BOREHOLE AND WELL DETAILS AT TANK 59 INVESTIGATION
MURPHY OIL USA, INC.
SUPERIOR, WISCONSIN

**INVESTIGATION
SAMPLING LOCATIONS
AND RESULTS
TANK 59 RELEASE
MURPHY OIL USA, INC
SUPERIOR, WISCONSIN**

Re: Work Plan for Investigation-Tank 59 Release
Murphy Oil USA, Inc., Superior, Wisconsin
PECFA Claim #54880-0456-07-K

Subject: Work Plan for Investigation - Tank 59 Release
PECFA Claim No. 354880-0456-07-K
Murphy Oil USA, Inc., Superior, Wisconsin

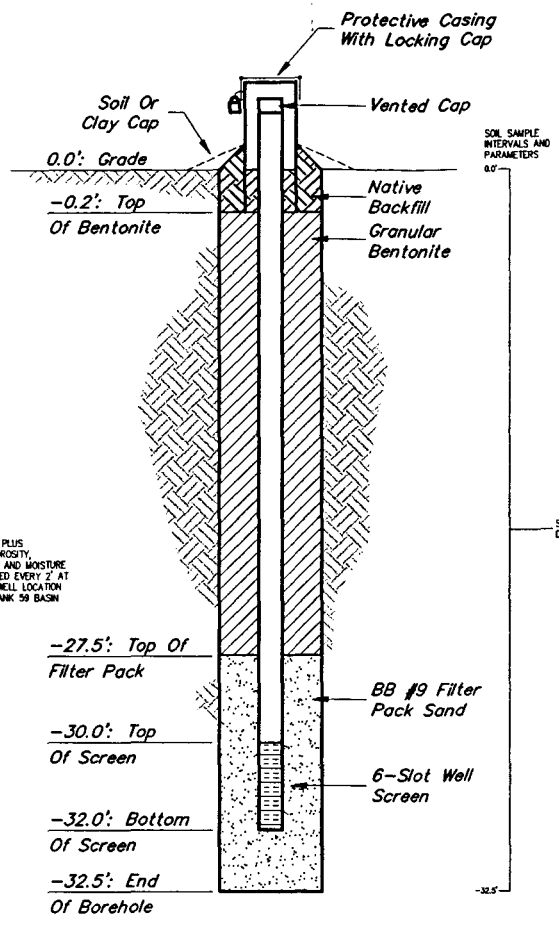
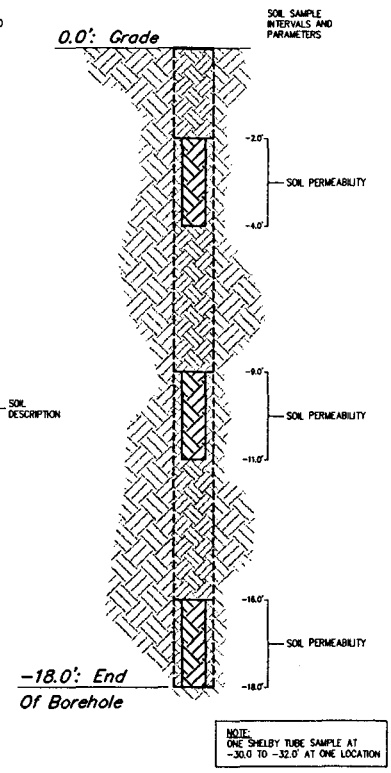
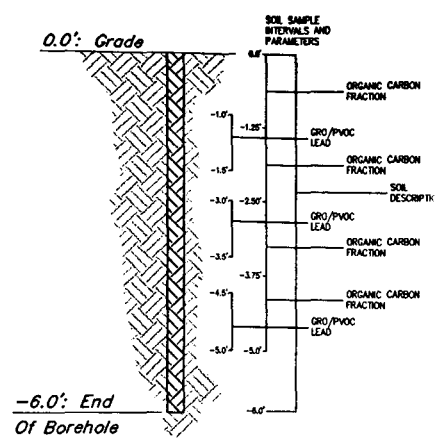
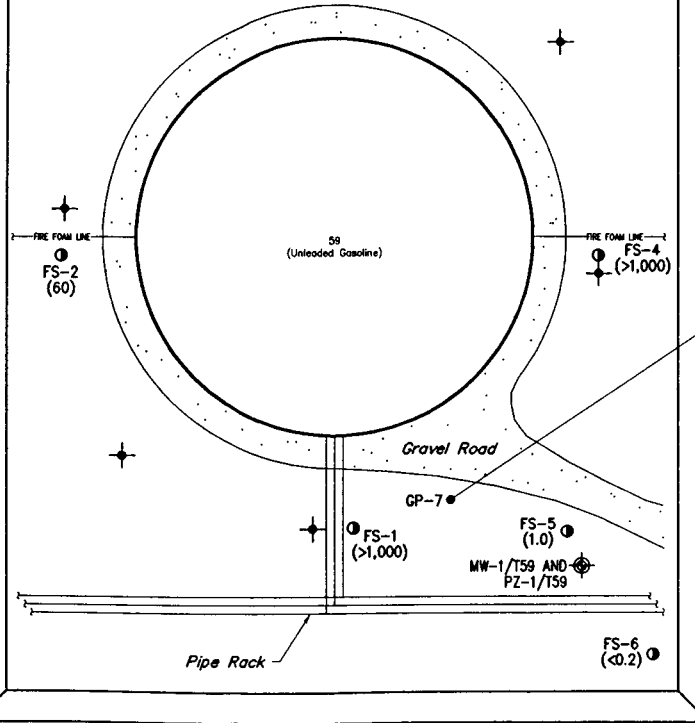
1. The results shall be submitted in accordance with NR 716.15, Wis. Adm. Code.
2. The report indicates the organic carbon samples will be collected from the site. We believe that the ranges of two to four percent identified in previous reports are not indicative of uncontaminated clay. The results may be indicative of petroleum contamination. Therefore, a sample must also be collected for organic carbon analysis from a nearby location off the refinery property.
